Our response to the proposal for Calderdale Energy Park (240 MW)

The 34-turbine proposal which we call CEP (240 MW), launched on 3 February 2026, should not be the proposal for the Direct Consent Order (DCO) application. It is a quick fix to try to get through the next stages of the planning process. The reason the developers have had to do so much work in a short time is that the Scoping Report was a disaster and has caused a five-month delay already.

[Analysis map for CEP 240 MW. © WTRG]

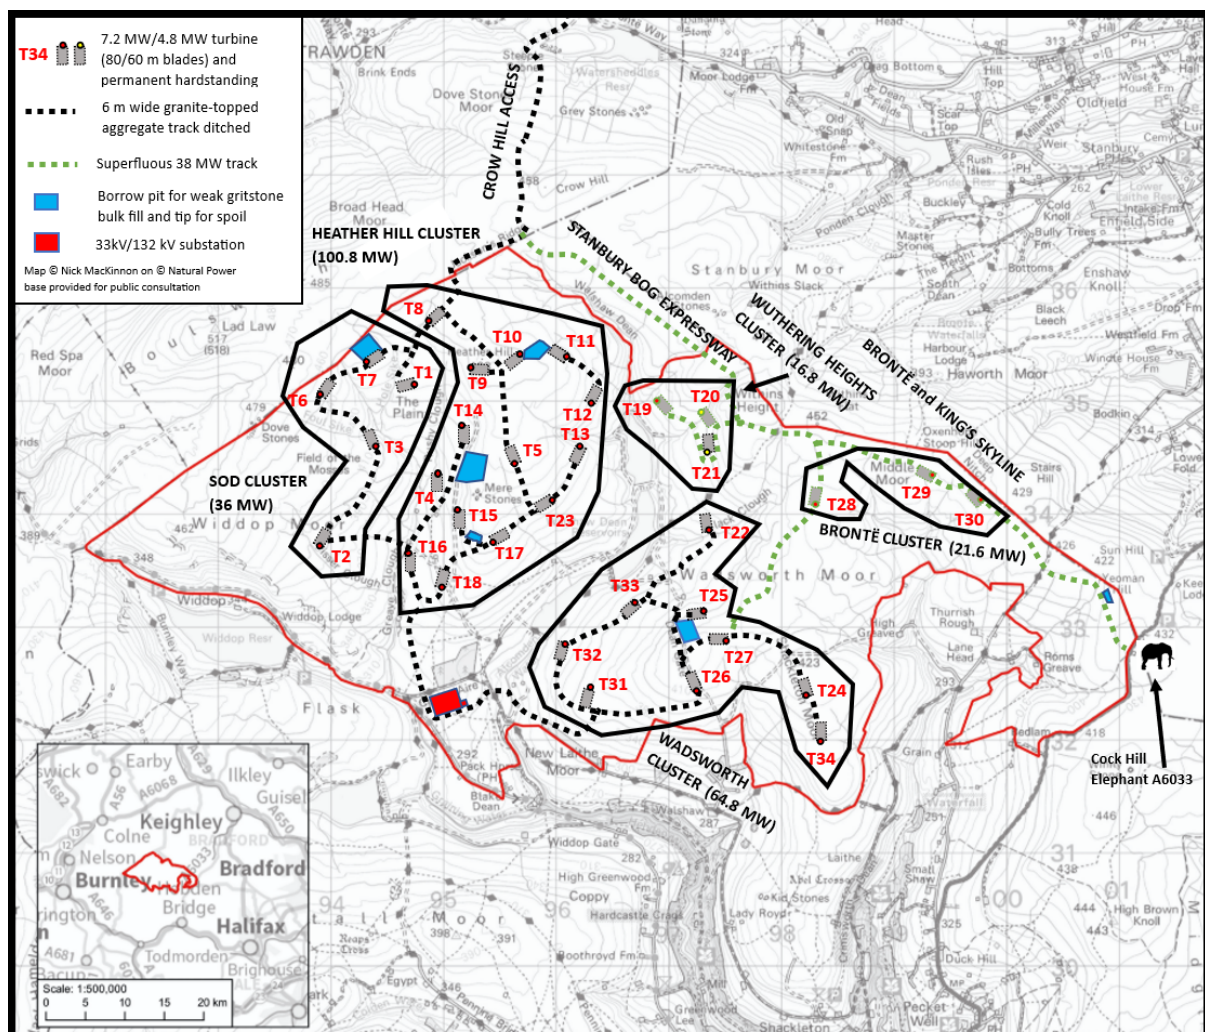
CWF Ltd have not yet published a proper map of the proposal, and they have not given exact positions for the turbines. All maps are © WTRG.

We analyse the proposal as five clusters (Heather Hill (100.8 MW) Sod (36 MW) Wadsworth (64.8 MW) Brontë (21.6 MW) and Wuthering Heights 16.8 MW). The total installed power is exactly 240 MW. The actual annual generation will be about 80 MW because the wind does not blow all the time. The small modular nuclear reactors, which may be part of the future of reliable electricity in the UK, are 300 MW constant.

[CEP 240 MW is grossly overcrowded. The rectangles are 3 RD by 5 RD downwind, and a SW prevailing wind is assumed. © WTRG]

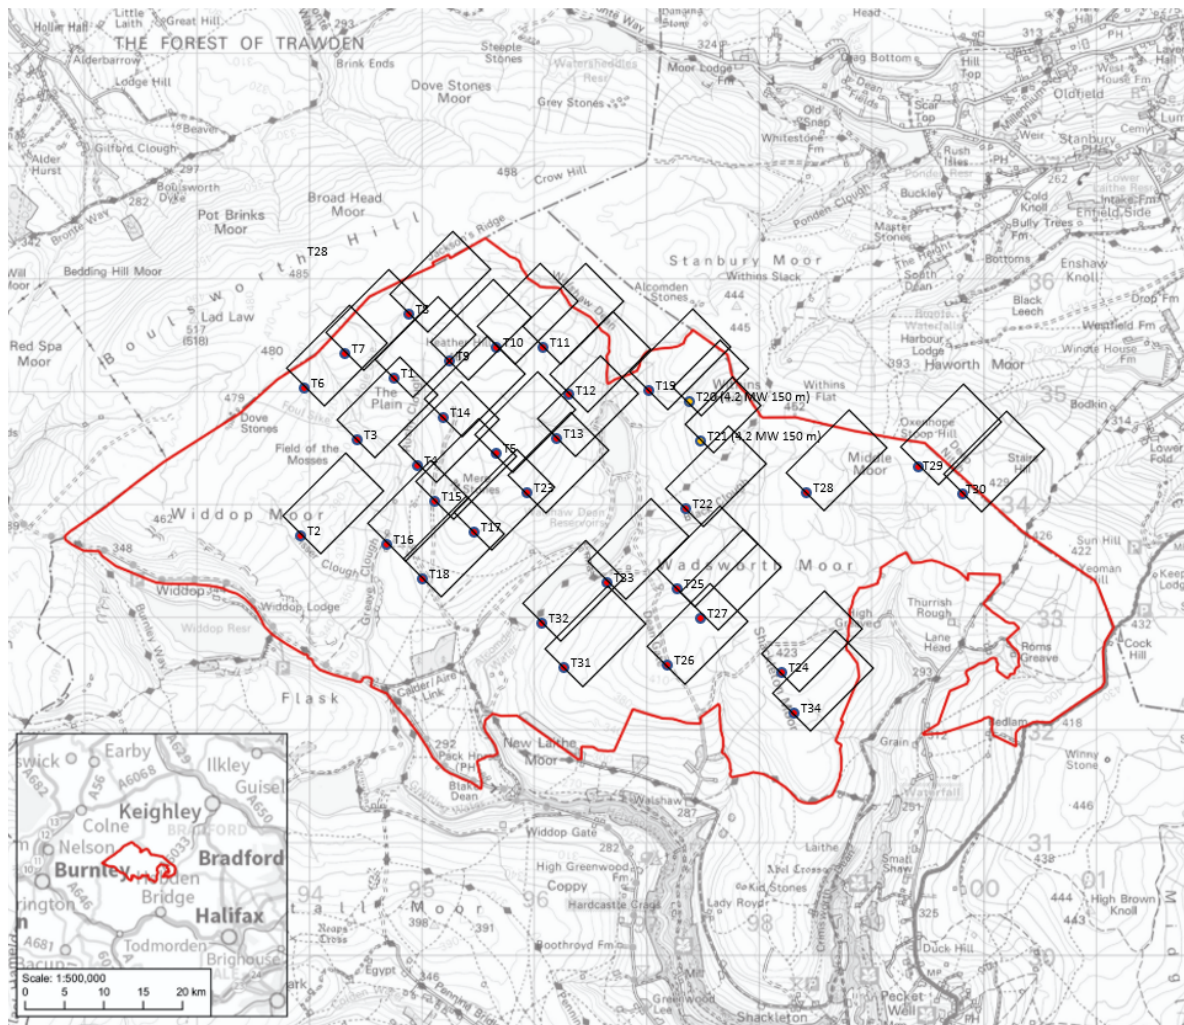
The diagram below shows the 3 RD by 5 RD spacings for CEP 240 MW. These rectangles should not overlap.

Were it permitted, the gross overcrowding of CEP 240 MW will be paid for by the British electricity billpayer. Since every Environmental Statement for a wind farm design begins with a statement on spacing, the layout given for CEP 240 MW is not viable.

[The original 65-turbine CWF (312 MW) with Vestas 4.8 MW/ 120 m turbines was correctly designed by reputable Natural Power using a 3 RD by 5 RD spacing. WTRG]

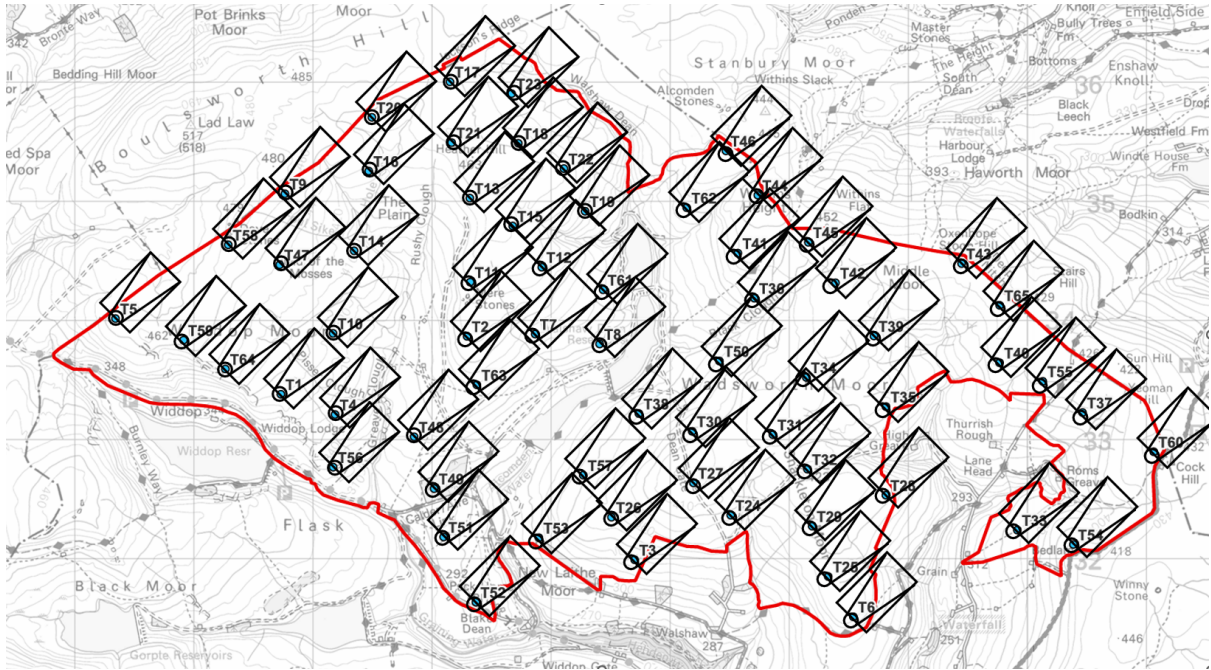
It is worth looking at the original 65-turbine layout of Calderdale Wind Farm, which has been described by the lead consultant of CEP, Donald Mackay, as “worse than useless”. It was designed by reputable Natural Power who have ceased to be the CEP consultants and was correctly spaced. This means that CEP 240 MW could be described as **much** "worse than useless".

Brontë Skyline and Wadsworth Plateau tracks

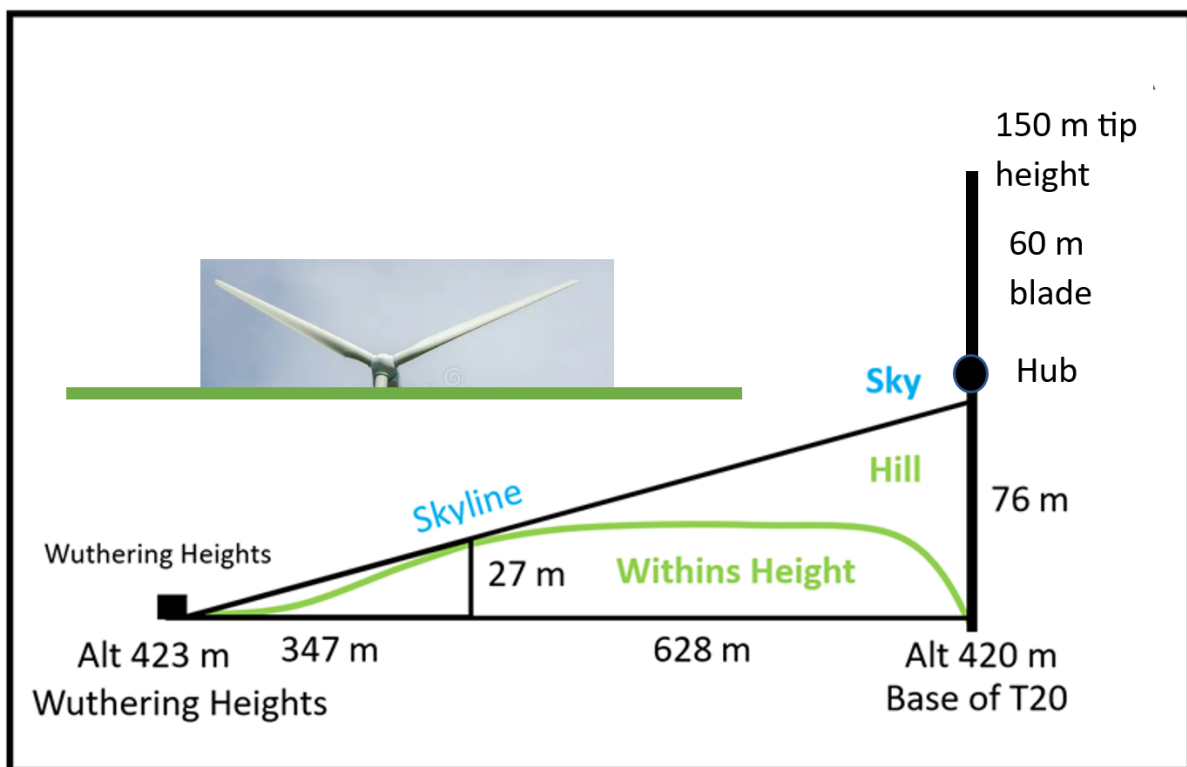
This track (marked in green on the map) is 10 km long and only serves the Bronte Cluster, T28, T29 and T30. The track continues to the Elephant on the A6033. Donald Mackay said that the purpose of the track is to reduce heavy traffic on the Colne side by delivering some HGV loads via Halifax, past Ovenden Moor WF. The example given was “a drum of cable”. He also observed that the track connects with the search area for the connection from the onsite 33kV/132 kV substation to the grid.

The pain for people on the stone routes can be hugely reduced by taking out the Brontë Cluster and this 10 km of track, which, since it is all on at least 2-metre deep peat, will be made of imported granite. This huge improvement for people, ecology, pollution, peat, and cultural heritage comes at a cost of only 21.6 MW. We will discuss the 132 kV cable and the cultural heritage implications later.
